**CITY OF WEST DES MOINES  
PLAN AND ZONING COMMISSION COMMUNICATION**

**Item:** Casey's, 108 8<sup>th</sup> Street – Approval to construct a 600sf building addition and 170sf cooler/freezer addition – Casey's Marketing Company – MaM-002887-2016

**Requested Action:** Approval of Major Modification to Site Plan

PROJECT: WEST DES MOINES, IA (#6) #2297 108 8TH STREET	DATE: 04-15-15 09-01-15 10-22-15 11-23-15 12-77-15	SITE PLAN
CONSTRUCTION DIVISION		AL-101

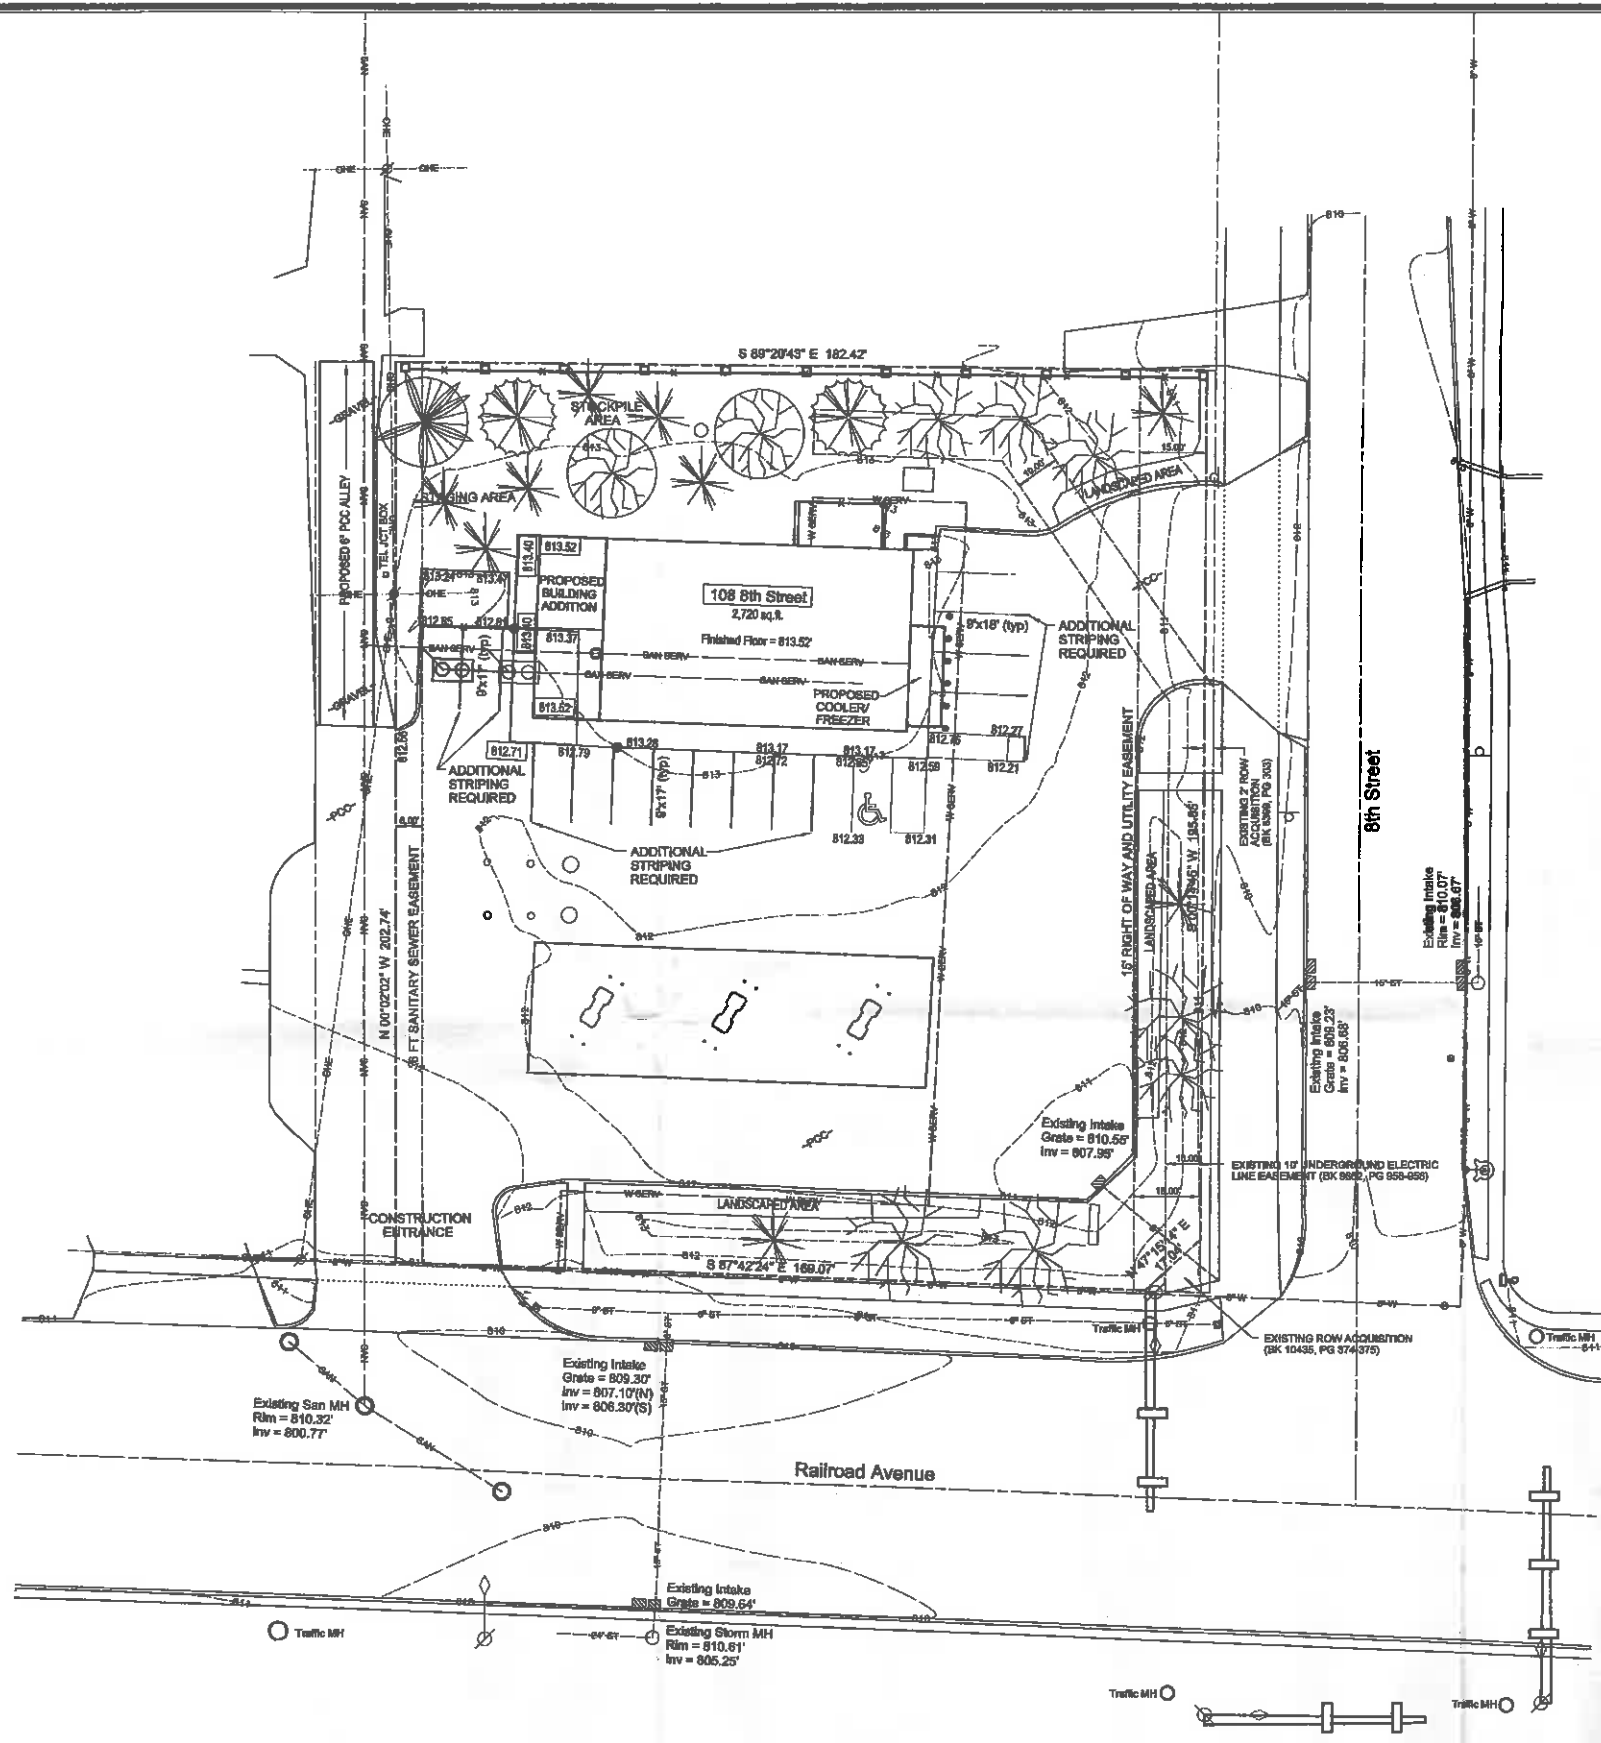
- **Railroad Avenue Right of Way:** Railroad Avenue is classified as a major arterial which per the standards identified in the City's adopted Comprehensive Plan, requires 120 feet of total right of way or 60 feet from the centerline. Currently the right of way adjacent to the Casey's parcel is 50 feet from the centerline. Railroad Avenue right of way is deficient 10 feet.

- **8<sup>th</sup> Street Right of Way:** 8<sup>th</sup> Street is classified as a major collector which per the standards identified in the City's adopted Comprehensive Plan, requires 100 feet of total right of way or 50 feet from the centerline. Currently the right of way adjacent to the Casey's parcel is 35 feet from the centerline. 8<sup>th</sup> Street right of way is deficient 15 feet.

- **Alley Paving:** Approximately the southern 115 feet of the 200 foot long alley immediately adjacent to the western border of the Casey's parcel is paved. Title 9: Zoning, Chapter 15: Off-Street Parking, Section 6-B3: Access states, "*Paving of the alley shall be required whenever a property, except a single-family detached residence, utilizes an alley as an ingress to an off-street parking area...*"

- ***Parking and Bollards in front of Cooler Addition***: The proposed cooler addition is located along the east side of the existing store. Bollards are planned to protect the cooler from the parking immediately adjacent. The cooler and bollards extend into the existing parking resulting in the stall length of two parking spaces which are less than allowed by City Code. These two stalls would not be useable except by compact cars or motorcycles. The site plan indicates that the site currently provides two parking spaces more than the minimum required of the site. Because the site has more parking than the minimum, the loss of these spaces is not an issue. "No Parking" signage could be installed at these stalls; however, if the applicant wishes to continue to offer these two spots as possible parking, the stalls should be marked for "compact cars or motorcycles only" so as to not have too long of vehicles extending into the drive aisle and potentially impacting circulation. Staff recommends a condition of approval requiring either the marking of these stalls as "No Parking" or "Compact Car Only Parking". Additionally, as indicated, bollards are intended adjacent to the cooler to protect it from being hit by vehicles. Staff also recommends a condition of approval requiring that the bollards be painted an earth-tone color compatible with the primary colors of the building and not a primary color (eg. red), safety yellow, or a corporate color.

- ***Right-of-Way***: The applicant's proposal to add a cooler and small building addition did not warrant the provision of right-of-way since modifications to the adjacent streets is not necessary to accommodate an increase in traffic due to the proposed additions.

- ***Alley Paving***: Paving of the remainder of that portion of the alley was not necessary as the applicant's site does not utilize that portion to directly access the off-street parking.

1. The applicant adding the appropriate signage to designate the parking stalls adjacent to the cooler addition as either “No Parking” or “Compact Car and Motorcycle Parking Only”;
2. The applicant acknowledging and agreeing that all bollards within the site are to be painted or covered in an earth tone color compatible with the primary materials of the building and not to be colored red, yellow, or a corporate color; and,
3. The applicant acknowledging that signage is not approved as part of the Major Modification. The applicant will need to obtain the appropriate Sign Permits from the City prior to installation of any new signage or changes to existing.
